## **WALKER RIDGE SUBDIVISION**

APPLICATION NUMBER 19 DATE June 21, 2007

REQUEST Subdivision

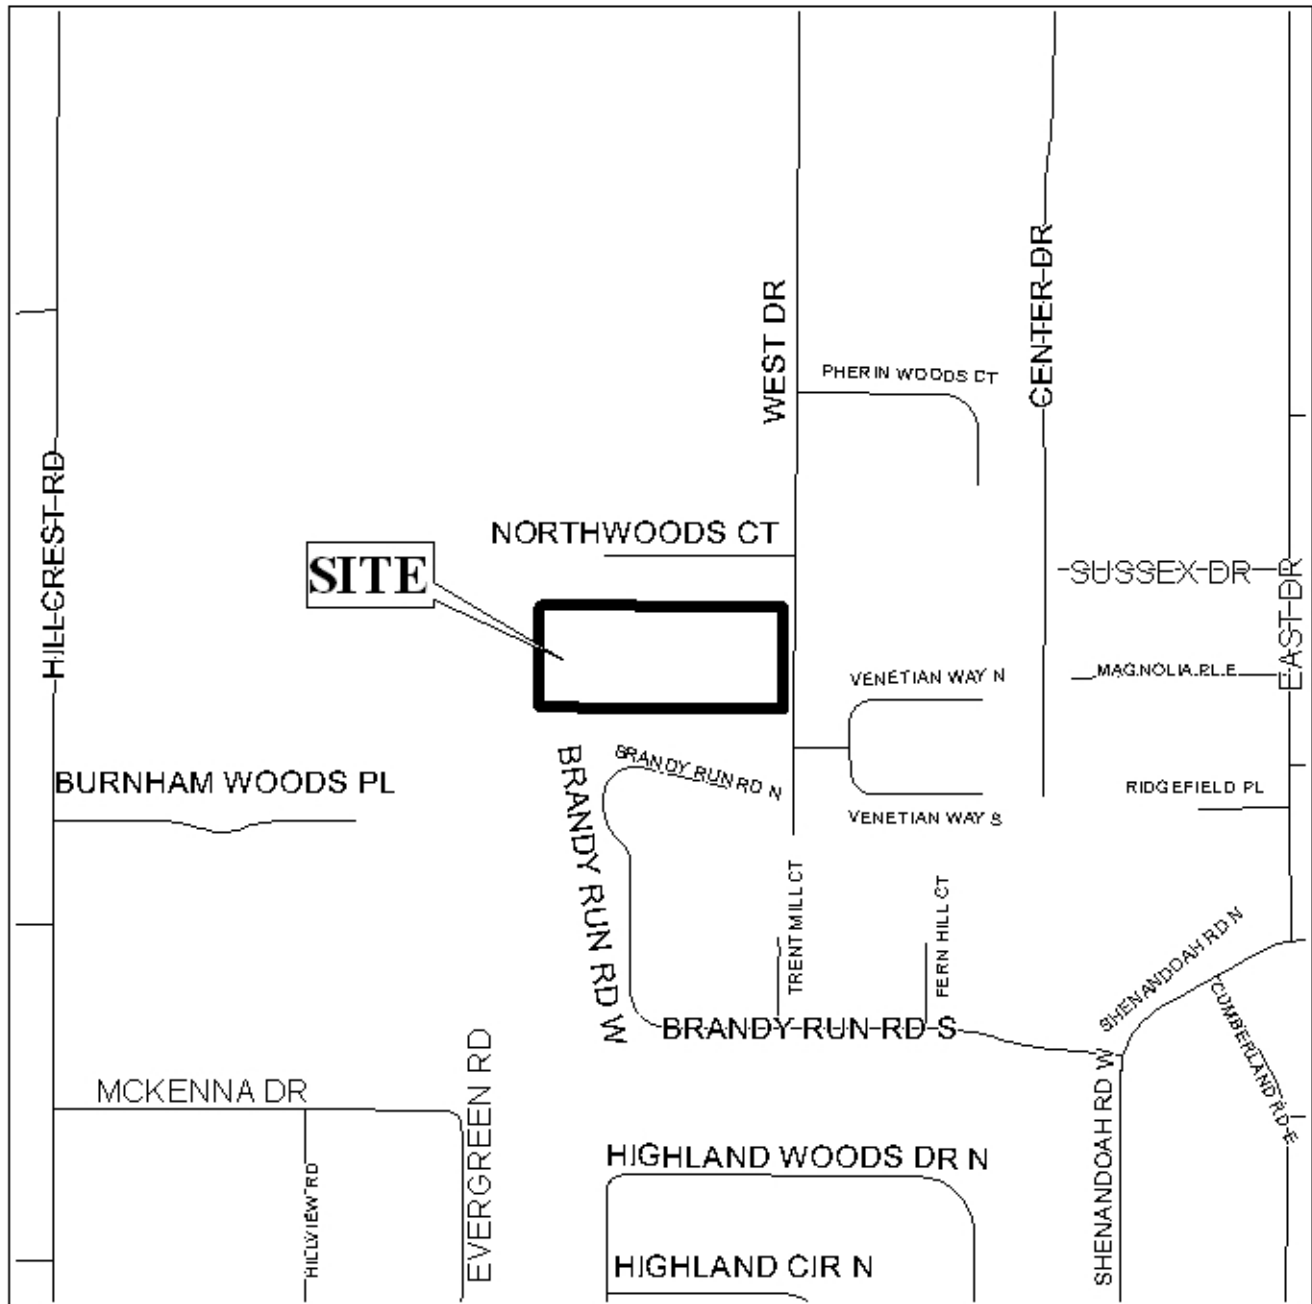
Engineering Comments: No concentration of water onto adjacent property is allowed without release agreement. Show floodway and flood plain. Show minimum finished floor elevation on each lot touched by flood way or flood plain. No fill in flood plain without flood study. It is the responsibility of the applicant to look up the site in the City of Mobile (COM) GIS system and verify if NWI wetlands are depicted on the site. If the COM GIS shows wetlands on the site, it is the responsibility of the applicant to confirm or deny the existence of wetlands on-site. If wetlands are present, they should be depicted on plans and/or plat, and no work/disturbance can be performed without a permit from the Corps of Engineers. Must comply with all storm water and flood control ordinances. Any work performed in the right of way will require a right of way permit.

Traffic Engineering Comments: Driveway number, size, location, and design to be approved by Traffic Engineering and conform to AASHTO standards.

Urban Forestry Comments: Property to be developed in compliance with state and local laws that pertain to tree preservation and protection on both city and private properties (State Act 61-929 and City Code Chapters 57 and 64).

The site fronts West Drive, a minor street with adequate right-of-way. Access management is a concern as two corner lots are proposed as part of the subdivision. A note should be placed on the plat stating that direct access from any lot to West Drive and the unopened public right-of-way on the West side of the site is denied, and that each lot is limited to one curb-cut, with the size, design and location to be approved by Traffic Engineering and conform to AASHTO standards.

The detention area and any other common areas should be labeled as common areas, and a note should be placed on the final plat, if approved, stating that maintenance of the common areas is the responsibility of the property owners.

- 1) depiction of the setback lines, as shown on the preliminary plat, with a 20-foot street side sideyard setback for Lots 1 and 18;
- 2) placement of a note on the final plat stating that all lots are denied direct access to West Drive and the unopened right-of-way on the West side of the site, and that each lot is limited to one curb-cut, with the size, design and location of all curb-cuts to be approved by Traffic Engineering and conform to AASHTO standards;

- 3) revision of the plat to label all common areas, including the detention area, and the placement of a note on the plat stating that the maintenance of common areas is the responsibility of property owners;

- 4) full compliance with Engineering comments (*No concentration of water onto adjacent property is allowed without release agreement. Show floodway and flood plain. Show minimum finished floor elevation on each lot touched by flood way or flood plain. No fill in flood plain without flood study. It is the responsibility of the applicant to look up the site in the City of Mobile (COM) GIS system and verify if NWI wetlands are depicted on the site. If the COM GIS shows wetlands on the site, it is the responsibility of the applicant to confirm or deny the existence of wetlands on-site. If wetlands are present, they should be depicted on plans and/or plat, and no work/disturbance can be performed without a permit from the Corps of Engineers. Must comply with all storm water and flood control ordinances. Any work performed in the right of way will require a right of way permit.*)

- 5) labeling of each lot in square feet, as depicted on the preliminary plat; and
- 6) full compliance with all municipal codes and ordinances.
